Re-Buncher RF Design overview

“CW Room Temperature Re-buncher
for the Project X Front End”

Subject: RE: QWR re-buncher aperture

Ø of aperture 40 mm vs. 30 mm

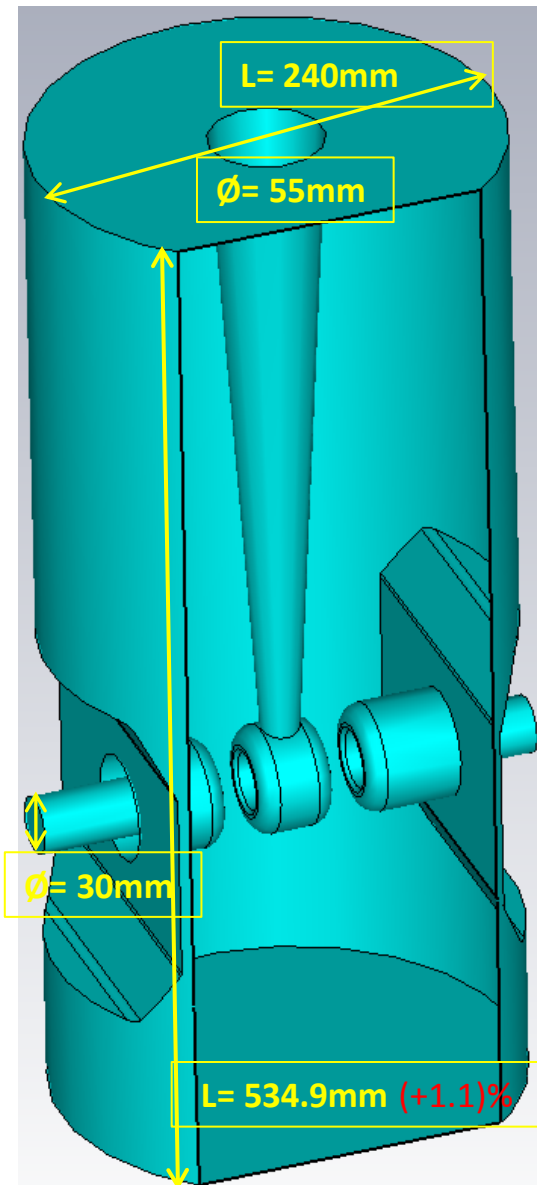
Presently the internal diameter of vacuum chamber in MEBT is ~28 mm. 30 mm ID in the cavity looks as a safe bet.

Currently QWR re-buncher aperture diameter is 40 mm. On the other hand I was told that the diameter of beam pipes in the MEBT is 30 mm, so it seems reasonable to reduce the aperture in the re-buncher. It doesn't mean that we need badly to do that. May be we will not, because there are other reasons to keep the aperture big. But it would be useful to know the minimal allowed aperture for final design consideration.

Q factor	10320 (-2%)
Aperture radius, mm	15
Gap, mm	2x23
Effective voltage ($\beta=0.067$), kV	70
Power loss in copper, kW	0.69 (25%)
Effective shunt impedance, Ohm	7.05e6 (33%)
Max. electric surface field, MV/m	3.6 (14%)
